# Access Compliance Report

## Public Rights-of-Way

### (Curb Ramps)

Intersection ID: 31445	Main Street: RIDING_HILL_AV	Cross Street: UNDERWOOD_AV	Location: E
ADA ID: 70BFEF79E639	Ramp Type: PerpDiag	Initial Pass/Fail: Fail	Overall Compliance: No
Severity Score: 21.25			
Codes/Mitigation Info/Possible Solution		Field Measurements/Component Compliance

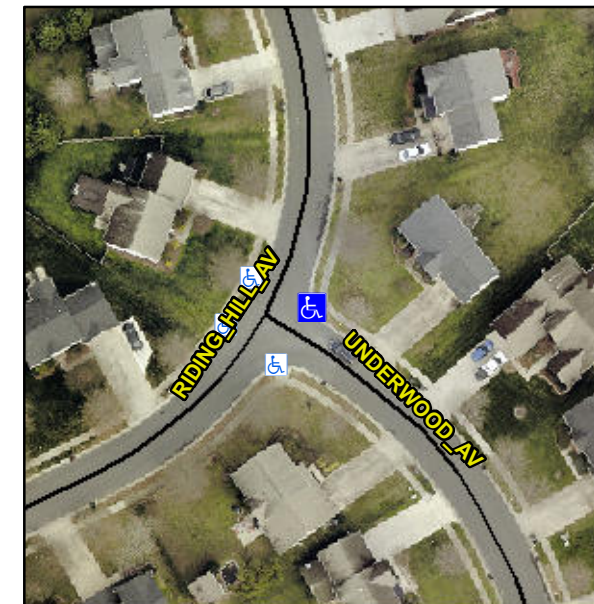
**Not Found, R304.5.1, R304.2.2**

Compliance	Description	Data	Compliance	Description	Data
N/A	Ramp Length (in)	48.0	No	Ramp Slope (%)	8.5
No	Ramp Width (in)	45.0	Yes	Ramp XSlope (%)	0.6
N/A	Flare Type LT	N/A	N/A	Flare Type RT	N/A
N/A	Flare Slope LT (%)	N/A	N/A	Flare Slope RT (%)	N/A
N/A	Flare Traversable LT?	N/A	N/A	Flare Traversable RT?	N/A
N/A	Landing Length (in)	N/A	N/A	DWS Provided?	N/A
N/A	Landing Width (in)	N/A	N/A	DWS Contrast?	N/A
N/A	Landing Slope (%)	N/A	N/A	DWS Length (in)	N/A
N/A	Landing X Slope (%)	N/A	N/A	DWS Full Width?	N/A
N/A	Landing Curb? (Y/N)	N/A	N/A	DWS Offset (in)	N/A
N/A	Shared Landing?	N/A			
N/A	Gutter Ponding?	N/A	N/A	Gutter Slope (%)	N/A
N/A	Gutter Lip Ht (in)	N/A	N/A	Gutter X Slope (%)	N/A
N/A	Painted X Walk1?	No	N/A	Painted X Walk2?	No
	X Walk 1 Direction	To NW		X Walk 2 Direction	To SW
N/A	X Walk 1 Width (in)	N/A	N/A	X Walk 2 Width (in)	N/A
	X Walk 1 Slope (%)	1.7		X Walk 2 Slope (%)	1.4
	X Walk 1 X Slope (%)	0.9		X Walk 2 X Slope (%)	1.3

**Remove & Replace Curb Ramp With Two New Directional Ramps or Equivalent.**
